Subject: Palo Verde Nuclear Generating Station (PVNGS)
Units 1, 2, and 3
Docket Nos. STN 50-528 (License NPF-41)
STN 50-529 (License NPF-51)
STN 50-530 (License NPF-65)
Revision to Technical Specification Amendment
Sections 1.0, 2.2, 3/4.1, 3/4.3, 3/4.10
File: 87-F-005-419.05; 87-A-056-026

ATTACHMENT 1
ANPP RESPONSE TO NRC REQUEST FOR ADDITIONAL INFORMATION

ATTACHMENT 2
Revisions to Temperature Dependent Shutdown
Margin Technical Specification Amendment Request

Figure 1-1

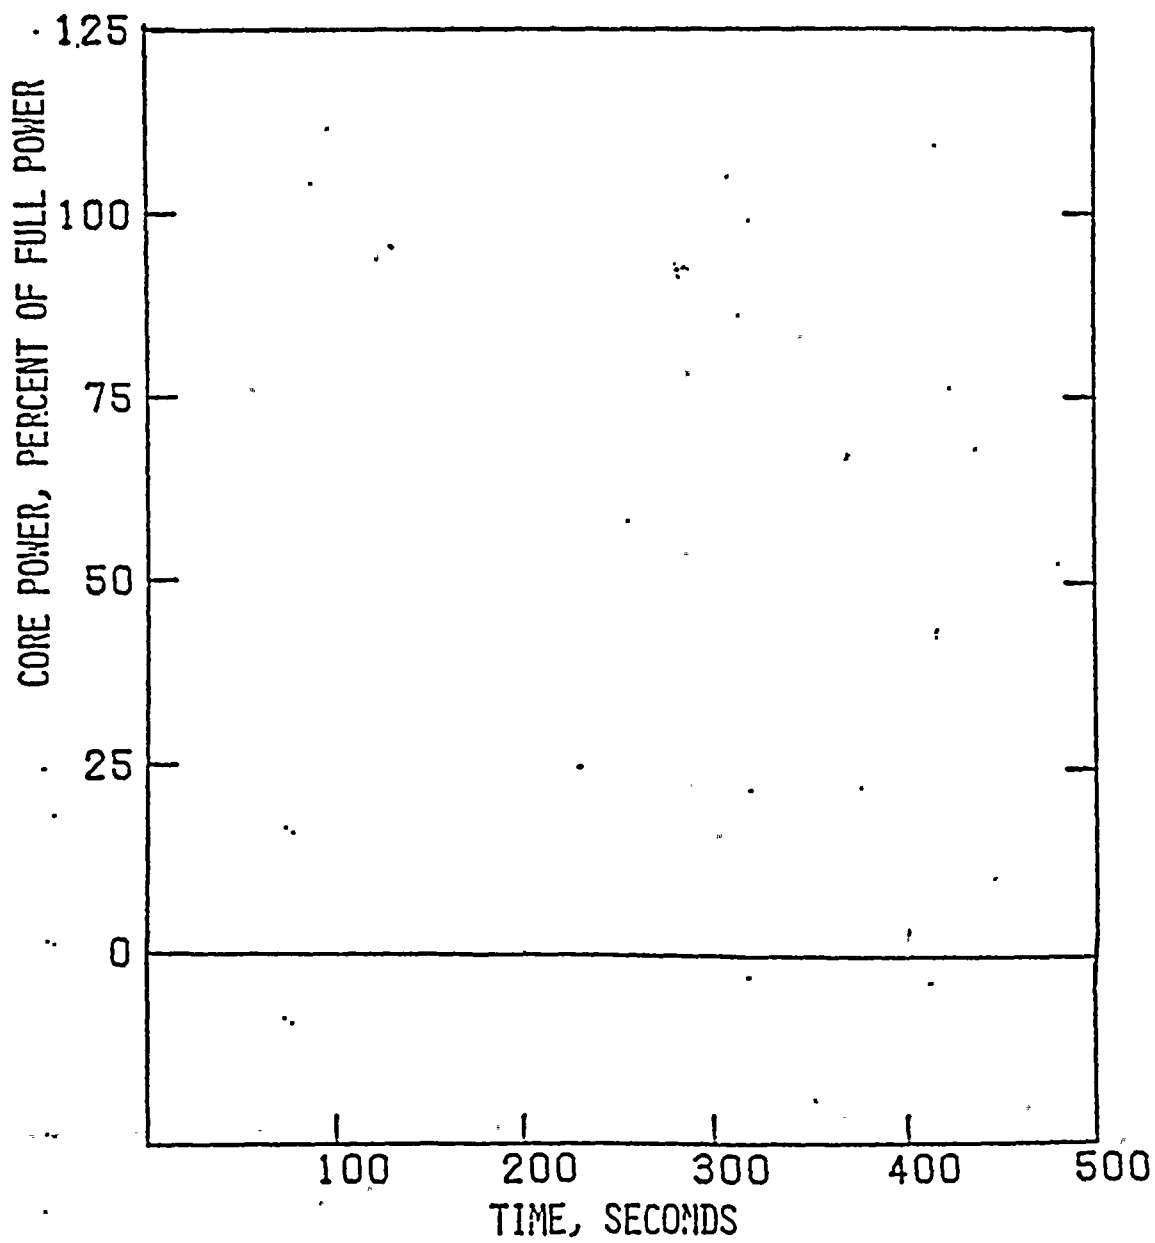
Many of the Figures accompanying the supporting analyses for the Technical Specification amendment request are unlabeled and some are also completely blank (e.g., Fig. 1-1, Fig. 1-2, Fig. 1-15). Please correct and update these.

Section H of the attachment to Reference (1) supplied the supporting analyses for the Technical Specification amendment request. Figures 1-1, 1-2, and 1-15 showed core power, core heat flux, and safety injection flow, respectively, as a function of time. These figures were for a large steam line break during Mode 3. As would be expected for Mode 3, core power and core heat flux are zero for the duration of the transient. In addition, the analysis states that during the first 500 seconds of the transient the pressurizer pressure remains above the Safety Injection Actuation Signal setpoint. Therefore, safety injection flow is also zero for the duration of the transient. These figures were originally scaled such that the curve was superimposed on the horizontal axis and it appeared that the curve was omitted from the figure. To facilitate the review of this amendment request, the figures have been rescaled such that the curves do not lie on the axis. Similarly, Figures 1-17, 1-18 and 1-31 have also been rescaled.
